ADDENDUM No. 3 TO THE CONTRACT DOCUMENTS

Project: City of Dillingham Streets Rehabilitation

Addendum Issue Date: July 18, 2019

Issued By: Michael Gemmell
PND Engineers, Inc.
1506 West 36th Avenue
Anchorage, Alaska 99503

SHEET NO: **F1** OF F7

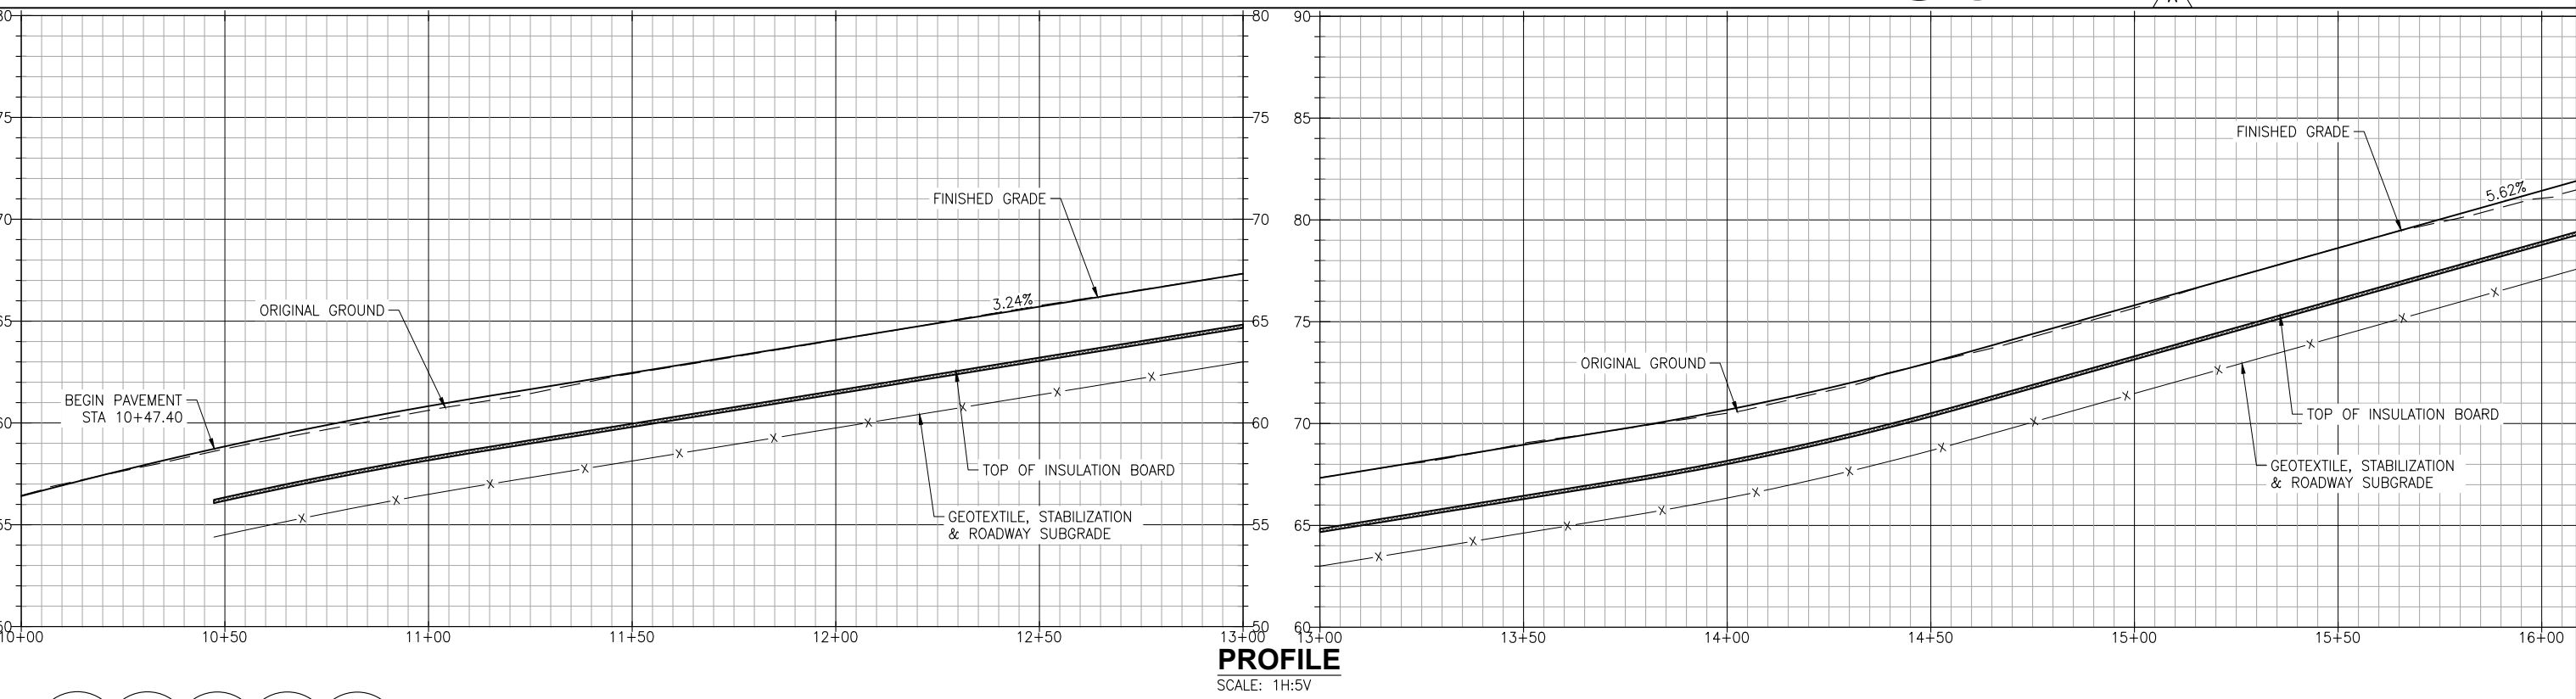
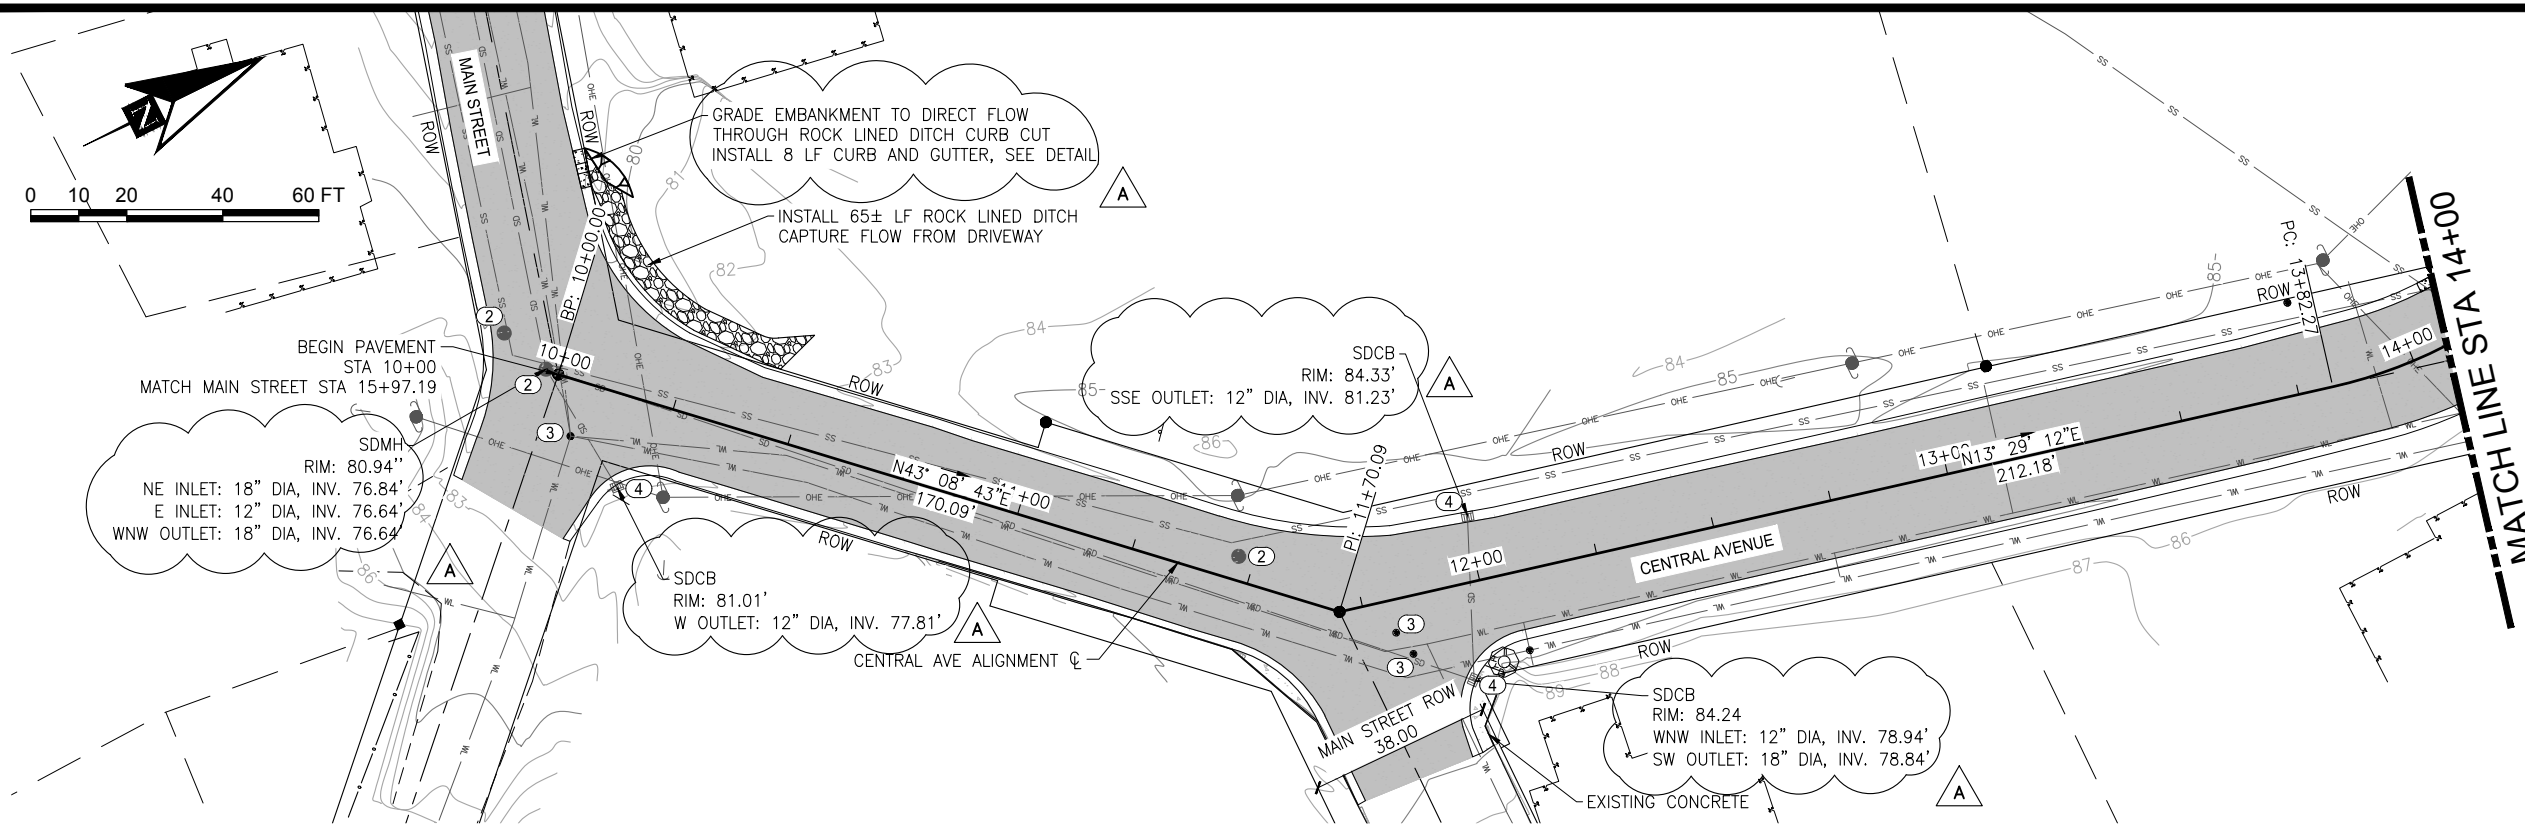
Replace current Plan and Profile Sheets F1-F7 with the Plan and Profile sheets attached with this Addendum. These sheets have been updated to include existing storm drain elevation information, modify work note number 3 to read “Adjust Valve Box” and identify additional curb and gutter replacement quantities.

DESIGNED BY: JG	DATE: 6/18/19	SHEET NO: F4 OF F7
CHECKED BY: PK	PROJECT NO: 181157

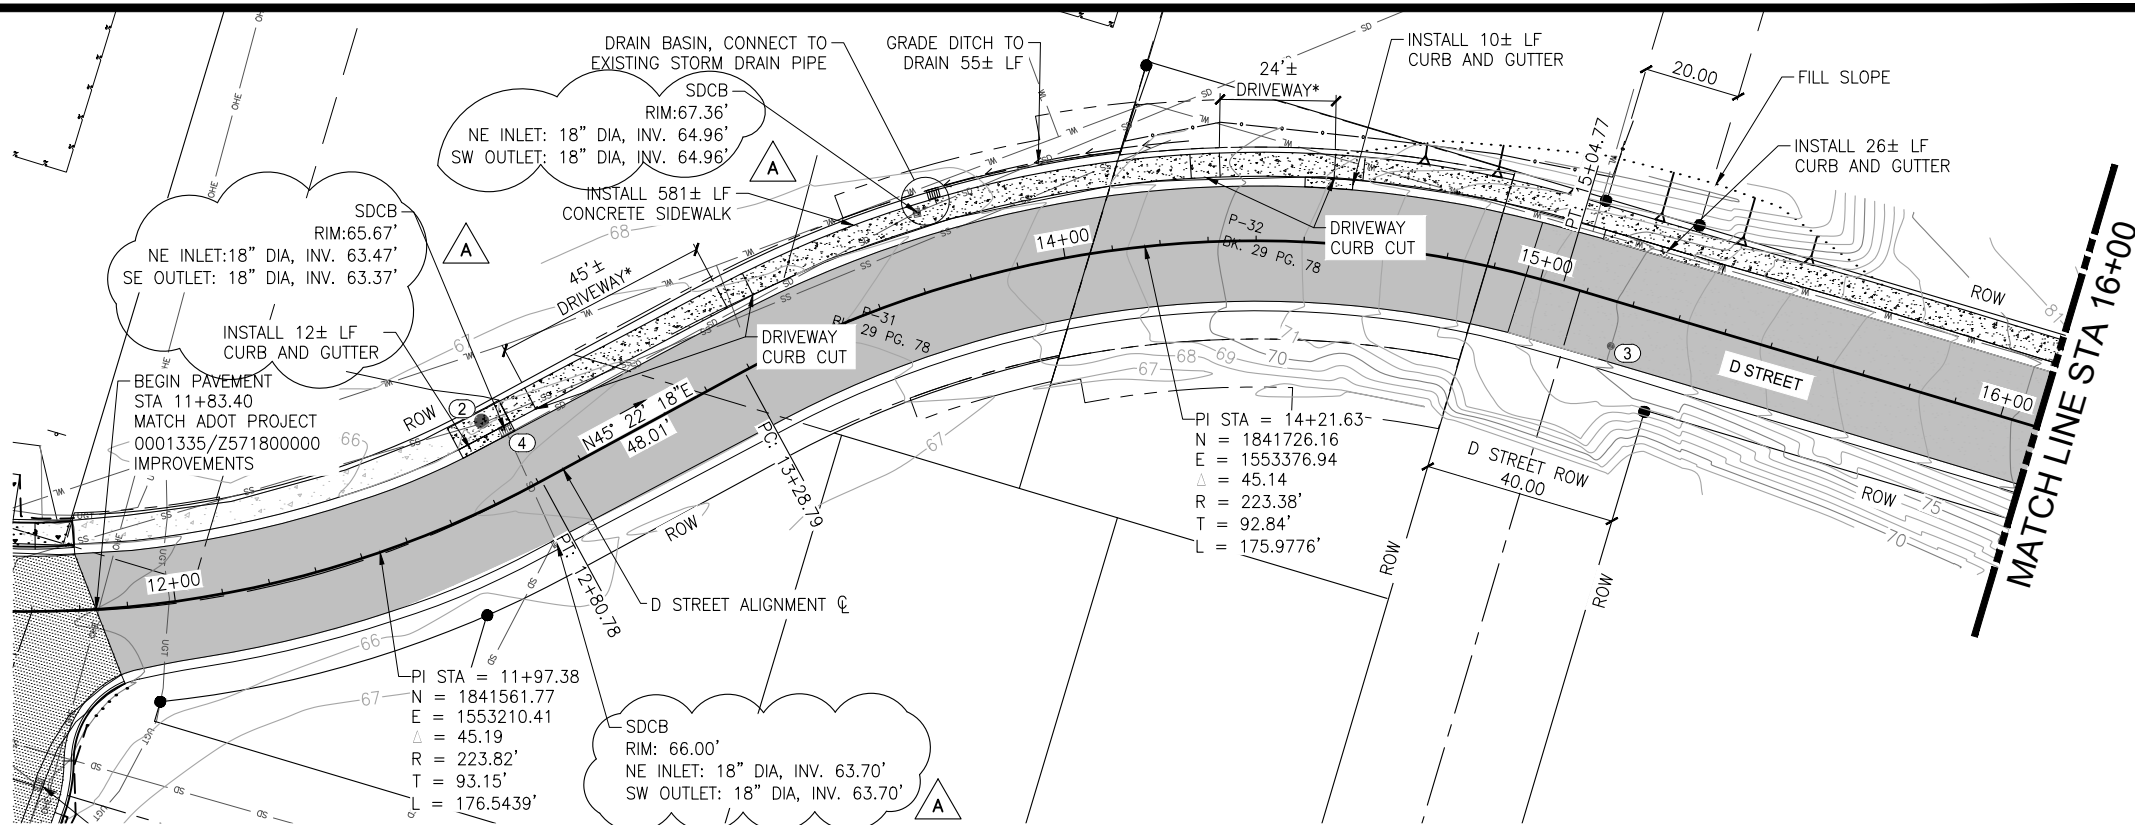
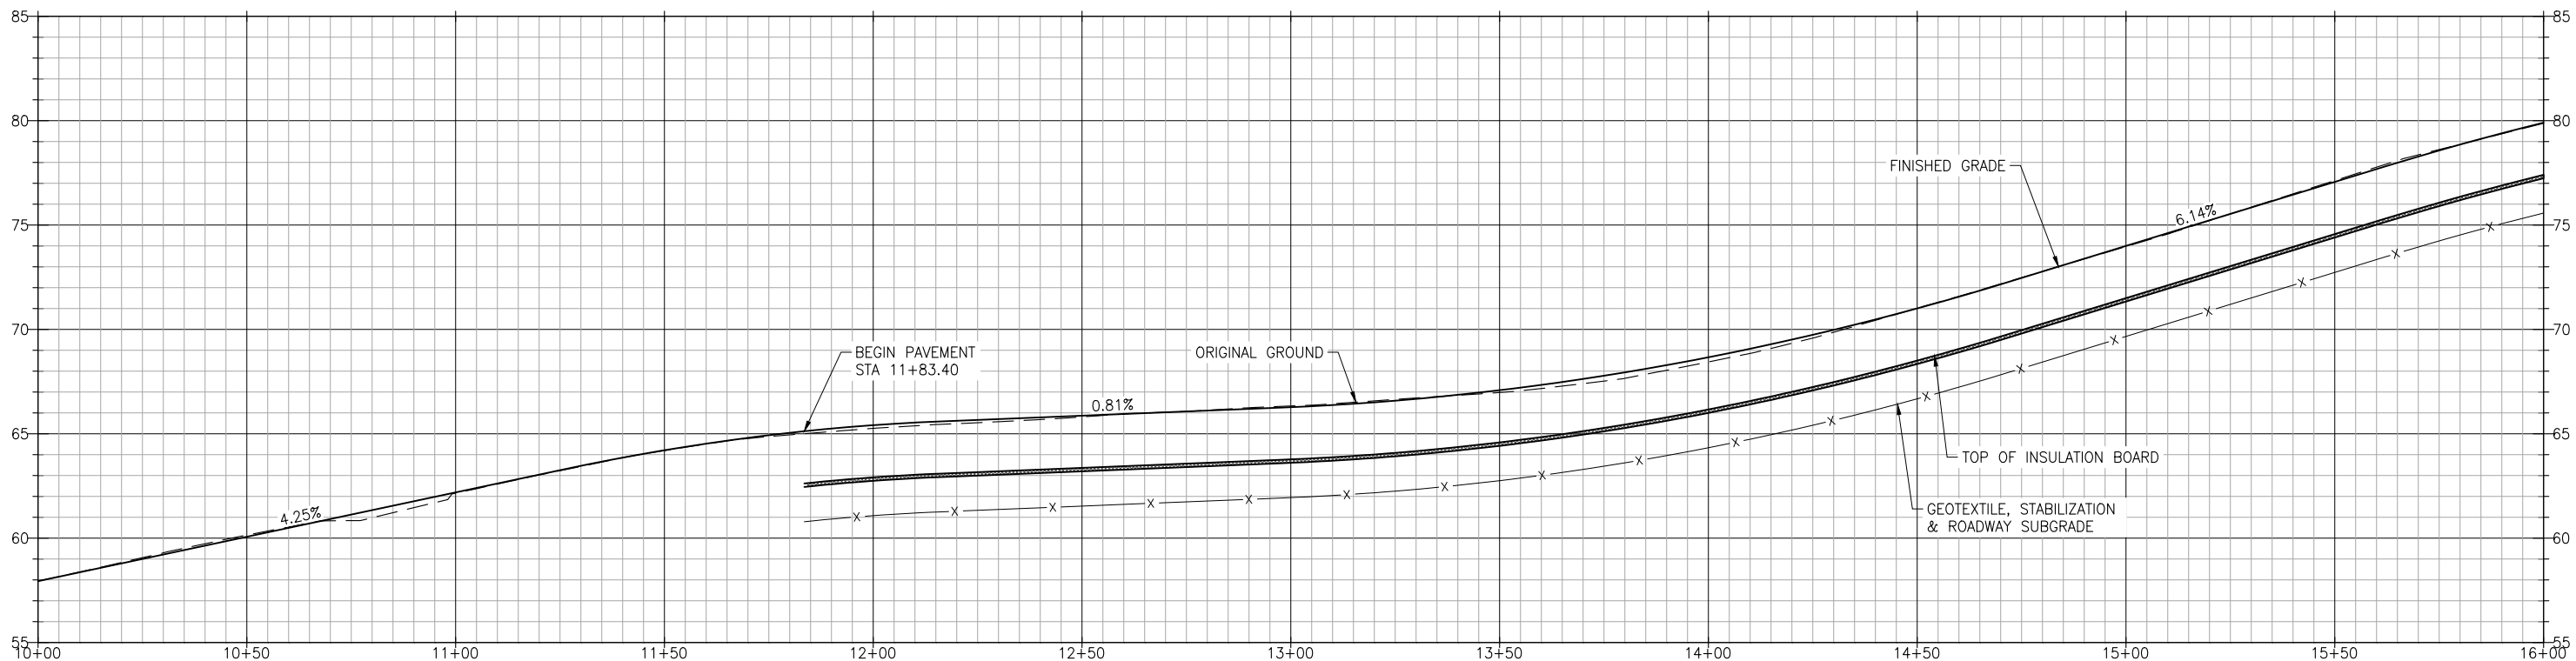
Add ADOT Standard Drawing I-20.20 to the list of standard drawings that are applicable to this Project.

NOTE:
* 6" CONCRETE SIDEWALK AT DRIVEWAY,
SEE ADOT STANDARD DRAWING I-20.20
